BEREWOOD : PHASE 2

Design and Access Statement - Addendum

REDR130524 : April 2014

Revised Site Layout April 2014

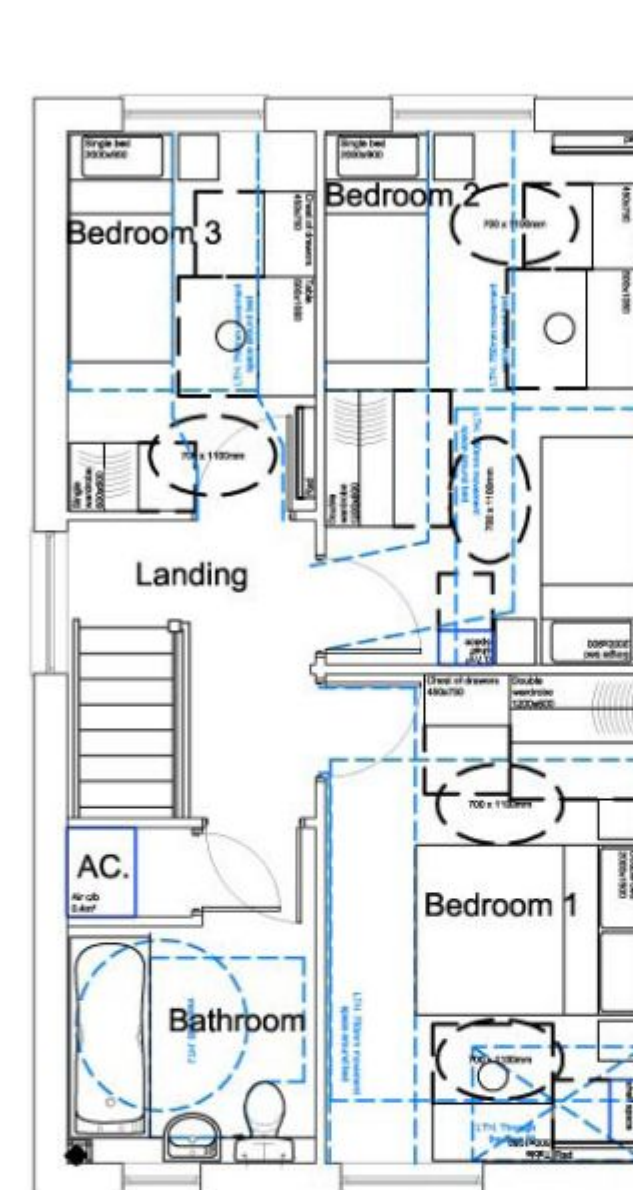
The bin collection points have been keyed with material surface treatments on the hard surfaces layout.

The parking in front of plots 93-96 has been reconfigured to provide parking better related to the properties, allow for additional landscaped areas and reduce the amount of hard surfaced.

The turning head between plots 133 & 134 has been redesigned to reduce the amount of hard surface and allow for additional landscaped area to soften this space.

Boundary details for screen walls/ fences and railings have been submitted at 1:20 scale as part of the revised submission. In particular the wall defining the courtyard to Flats A has been reduced in height to a low level (as requested) to low visual permeability to be maintained between the affordable and private housing areas.

Housetype Dart Variation A
GROUND FLOOR

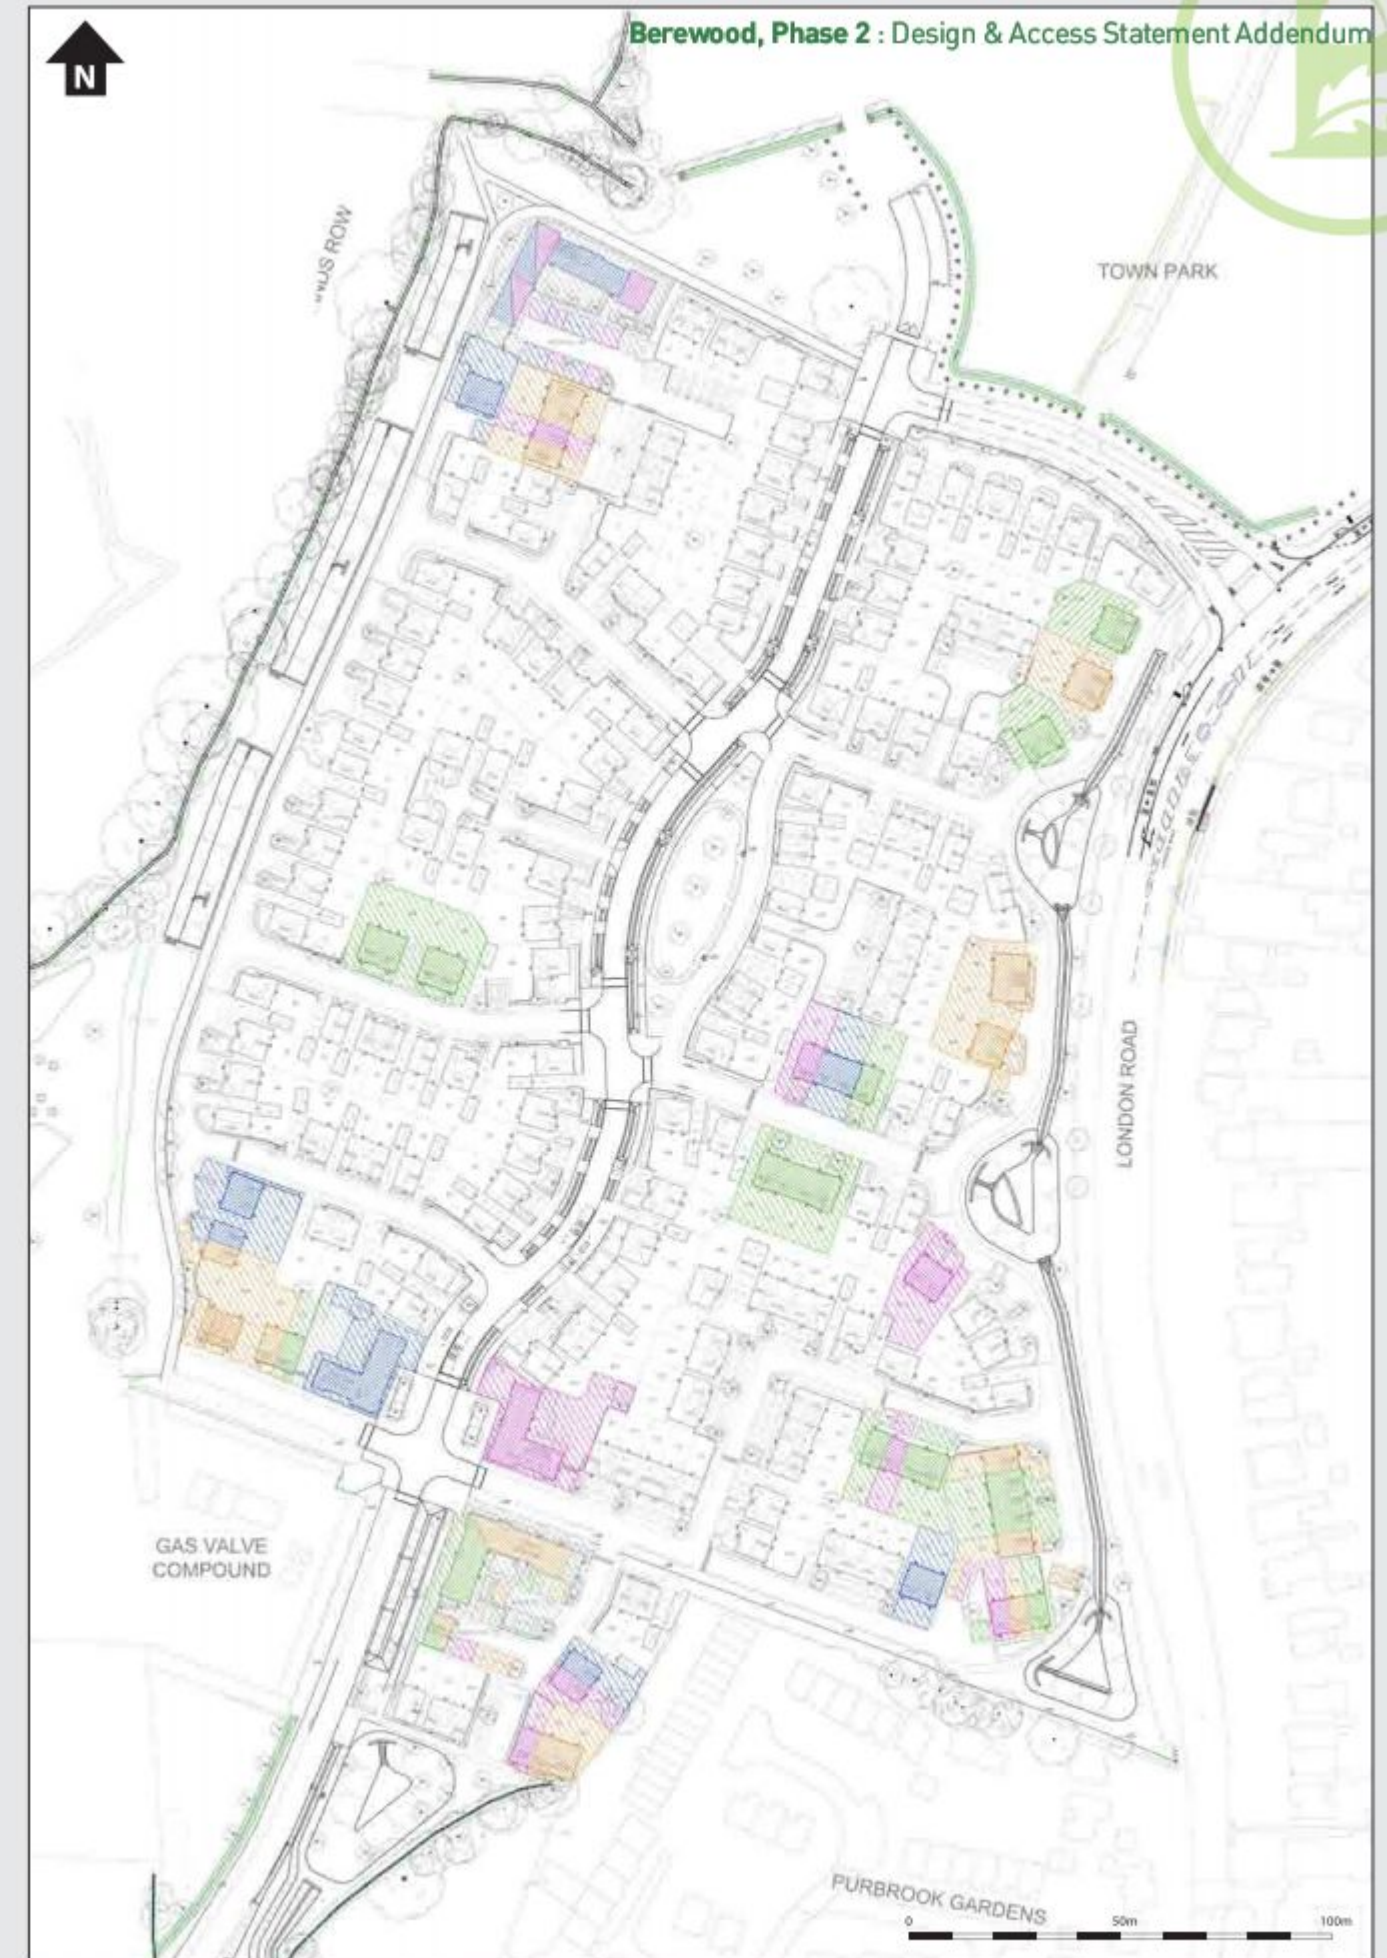
All the affordable homes and flats have been redesigned to be Lifetime Homes compliant. The amendments have resulted in an increase in the size of all properties to accommodate the 16 point requirements of Lifetime Homes. The scheme including private units is now fully Lifetime Homes compliant.

Architectural Detailing - Flat Block A Elevation Facing Public Green

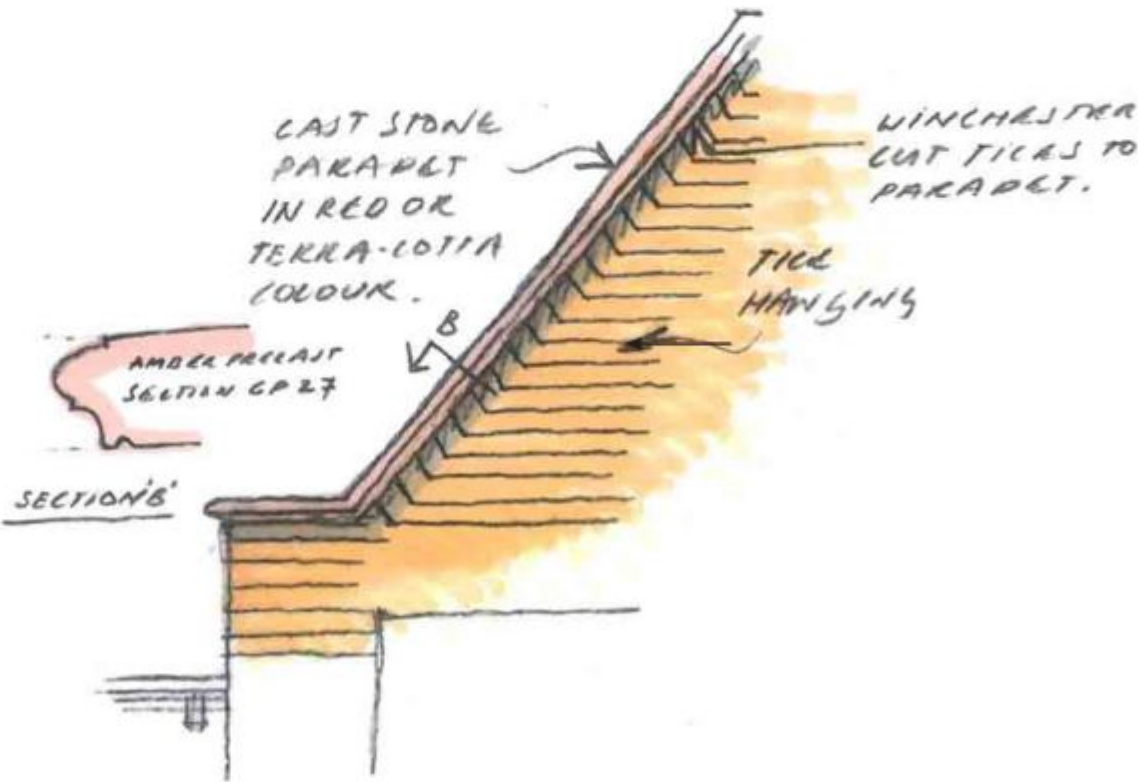
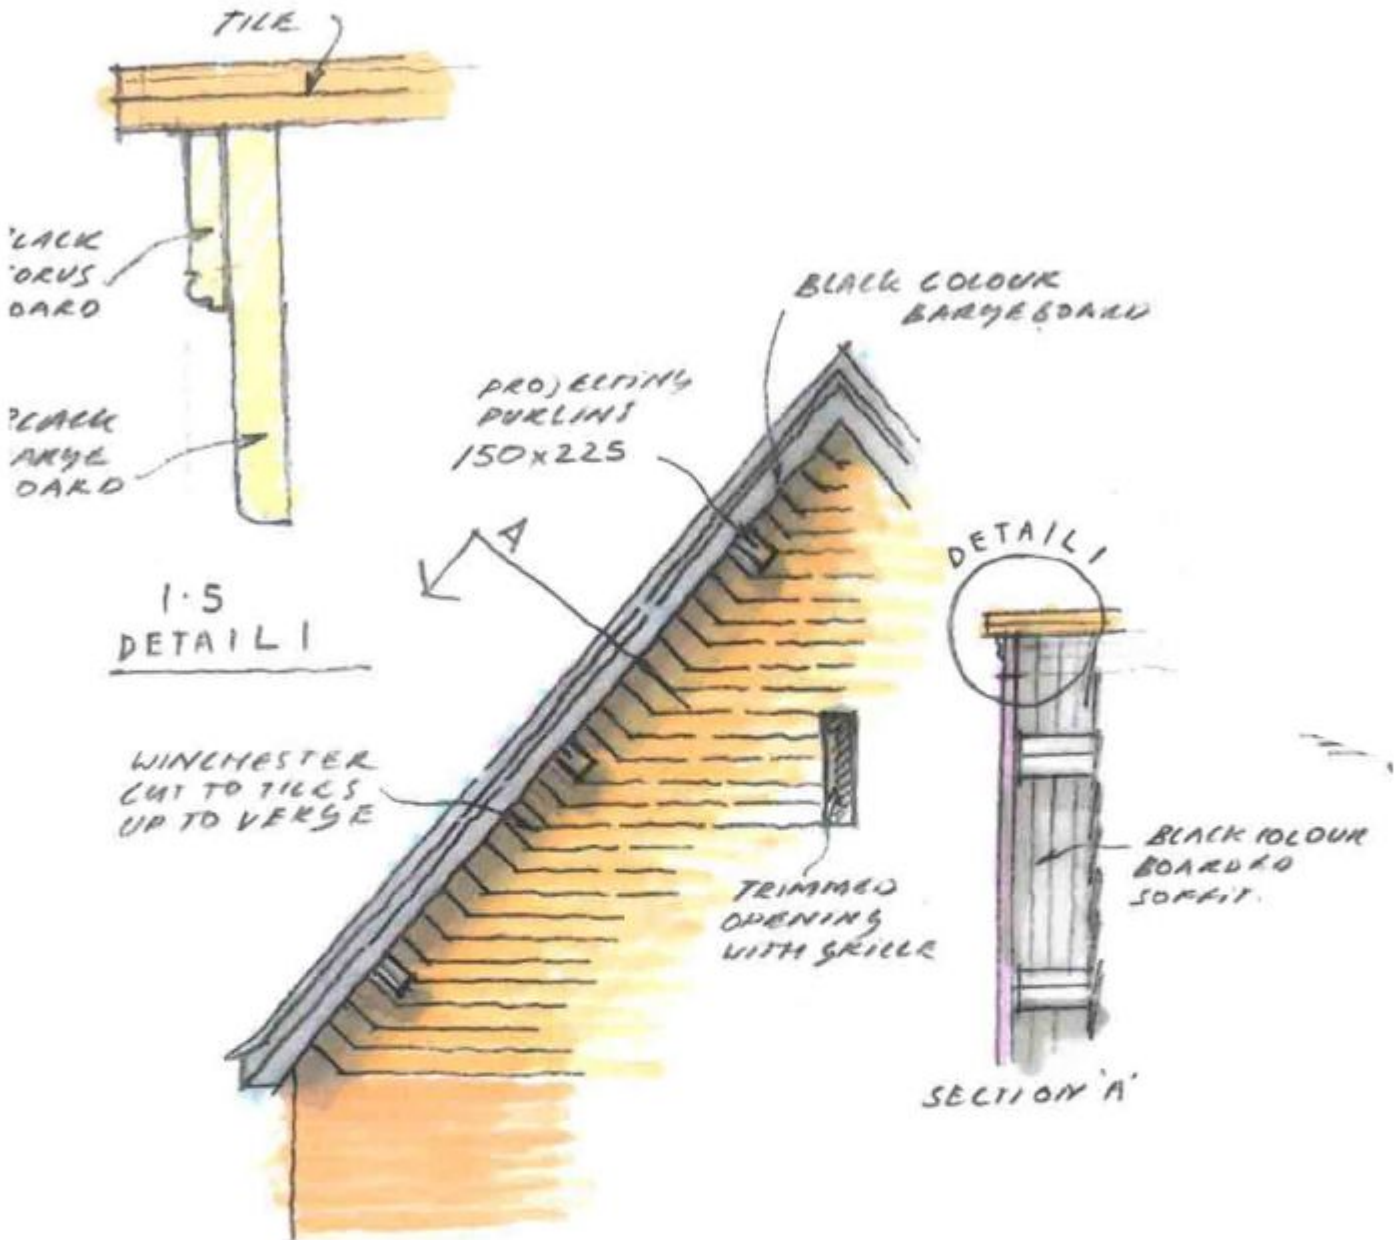
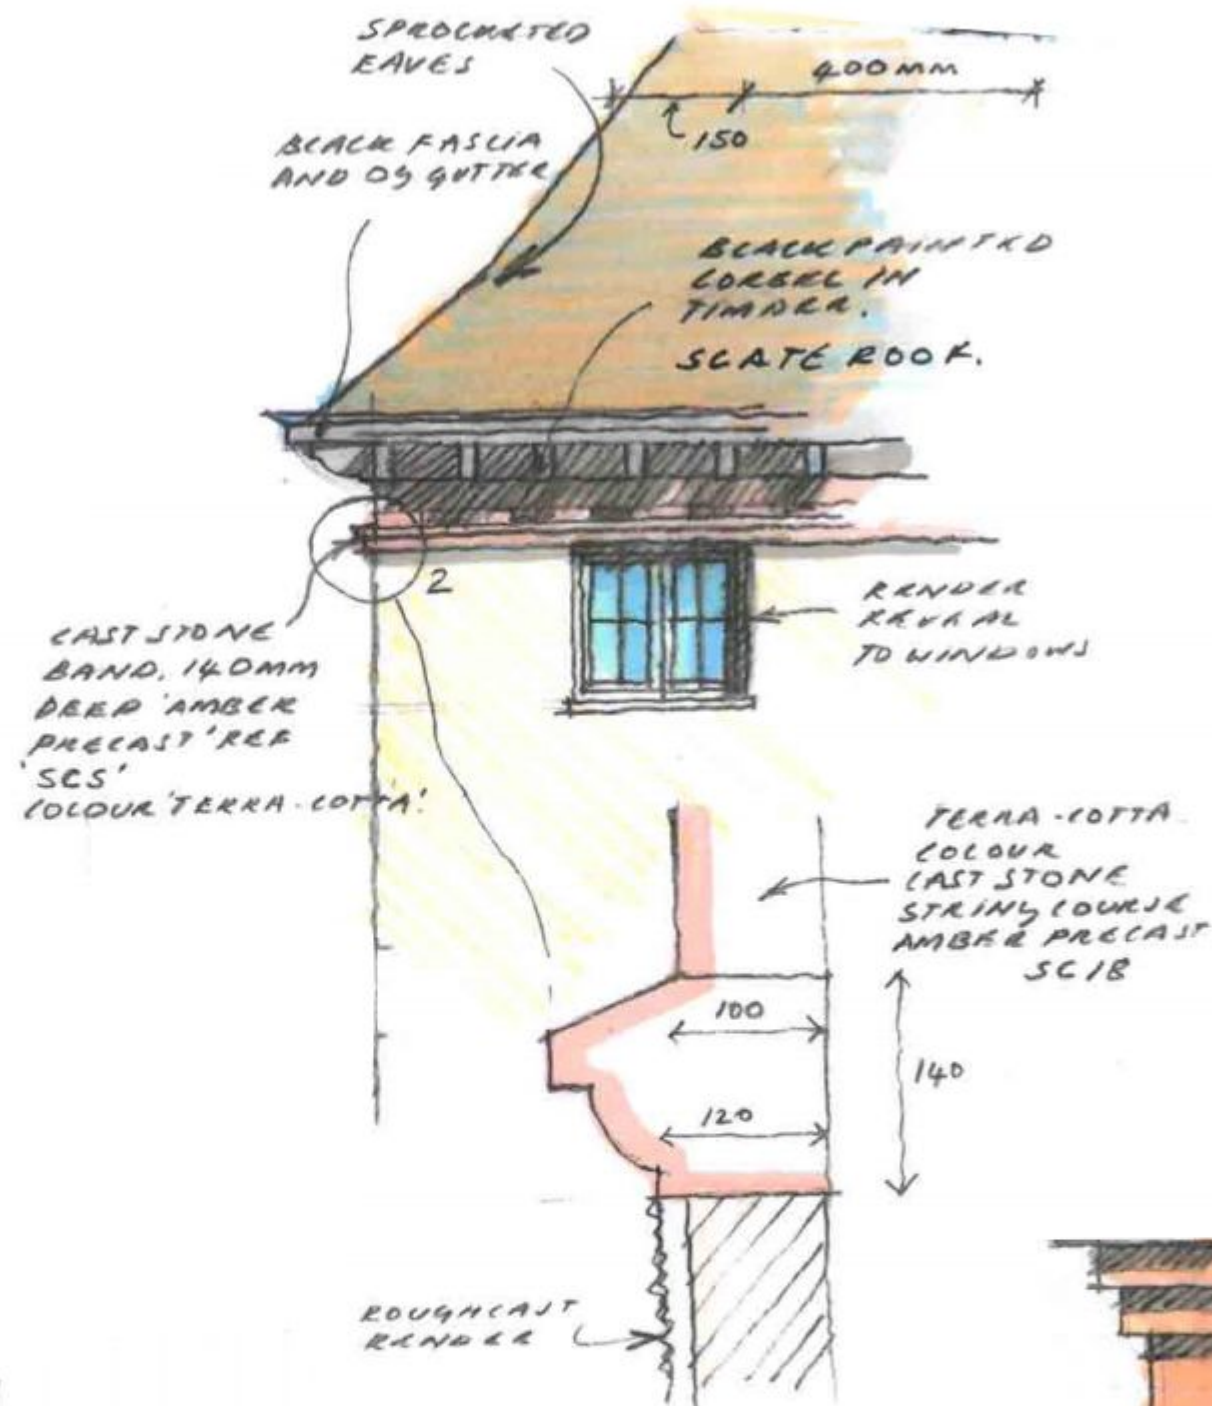
Comments on the elevational appearance of Flat Block A related to the lack of attention to detail in the cad drawings when contrasted with the hand-drawn version. Rather than add extraneous features our approach has been to examine the elevation and enhance the architectural detail of main elements which are;

- the pair of rendered towers at each end of the elevation
- the central tile hung gable.

Sketches and coloured diagrams show where the original elevation has been amended and the details that are to be enhanced.

Tracking

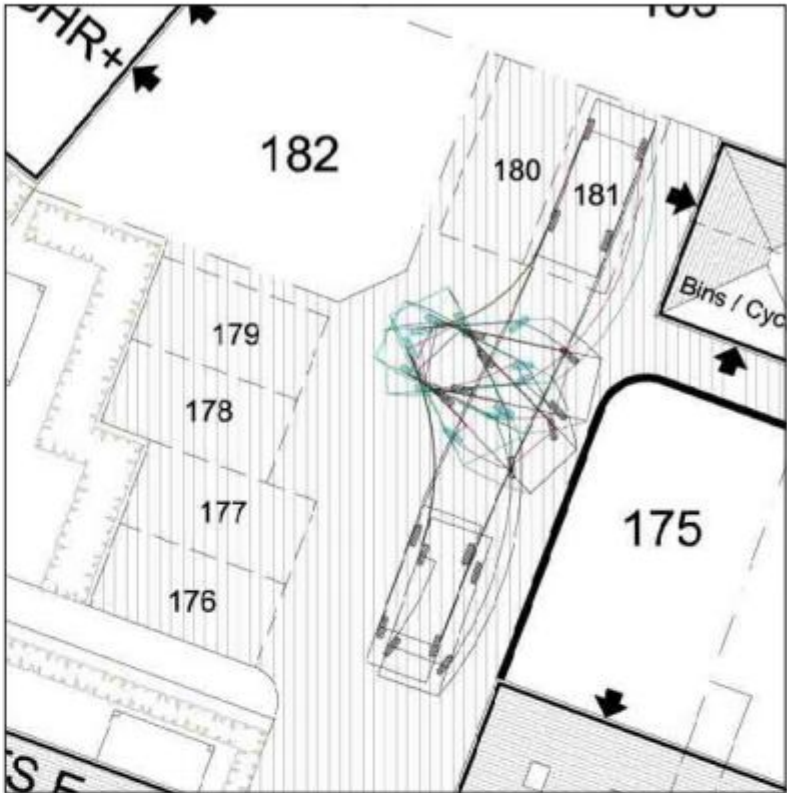
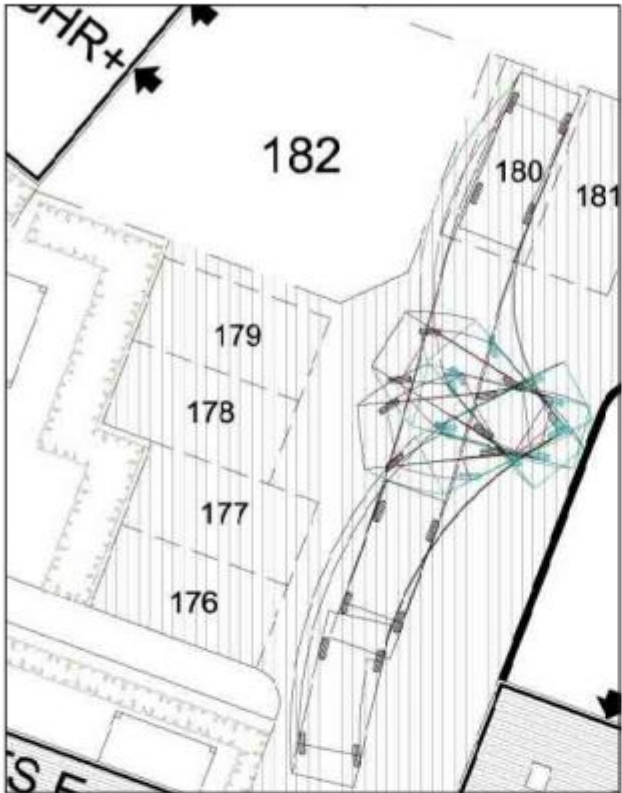
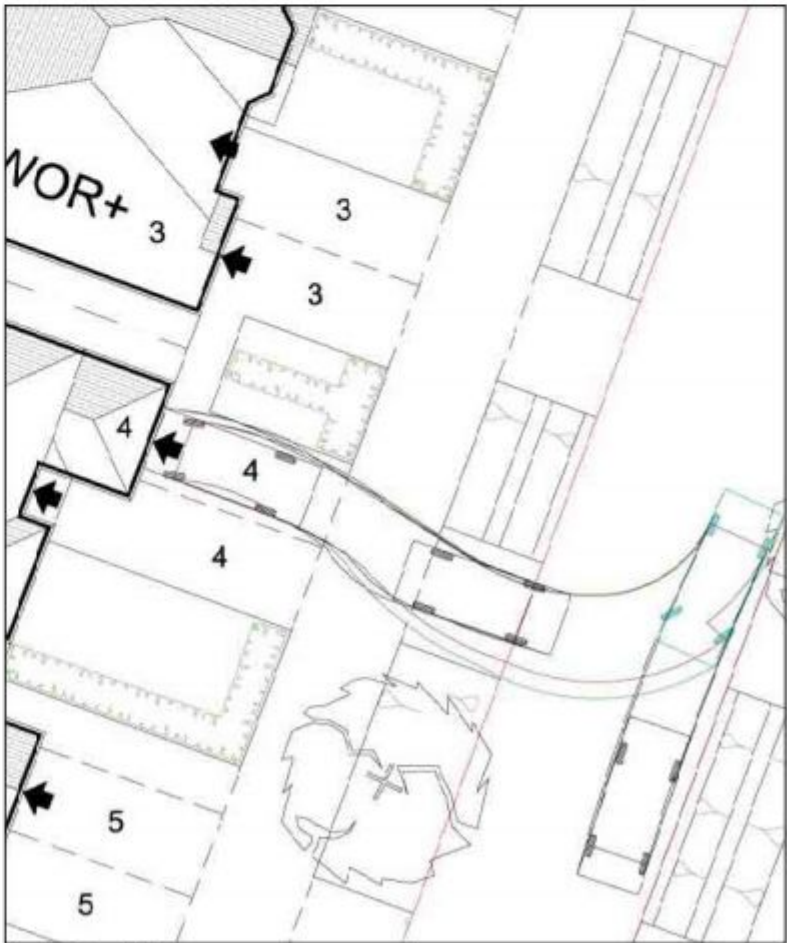
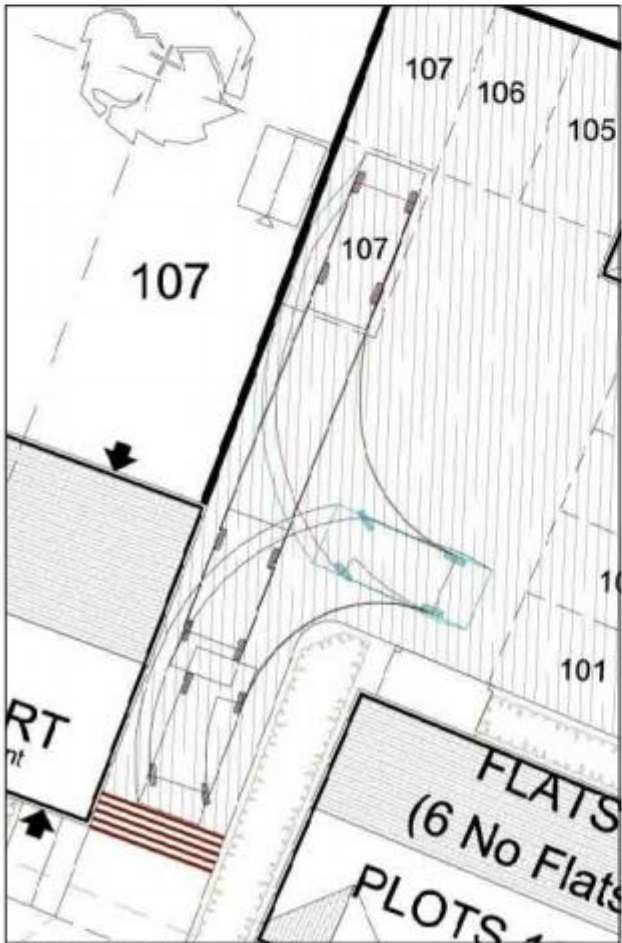
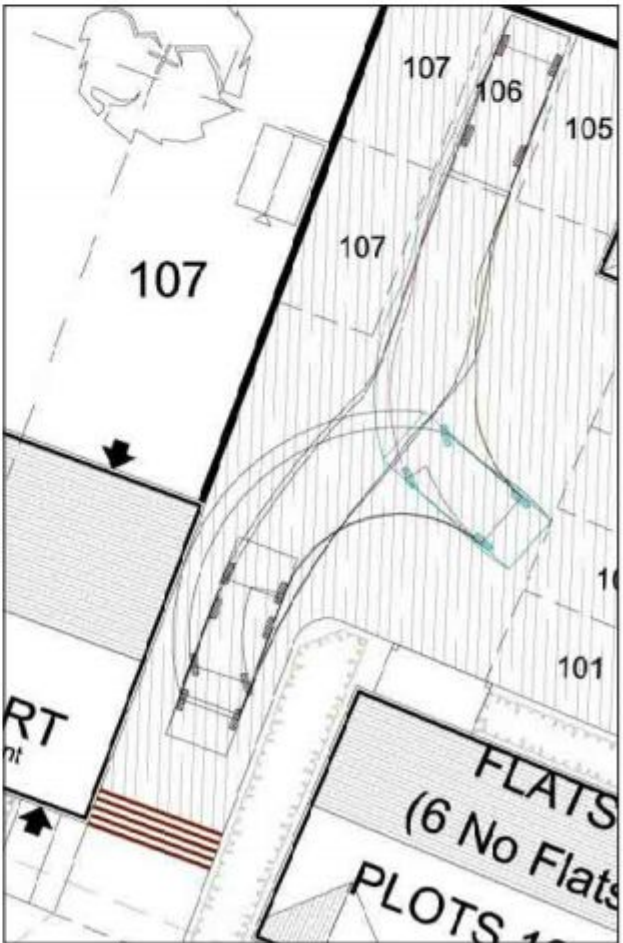
Several of the tighter parking courtyards and the revised design for the cross over to the swale have been tested for vehicle tracking. An extract of the track plots is shown on the accompanying plans.
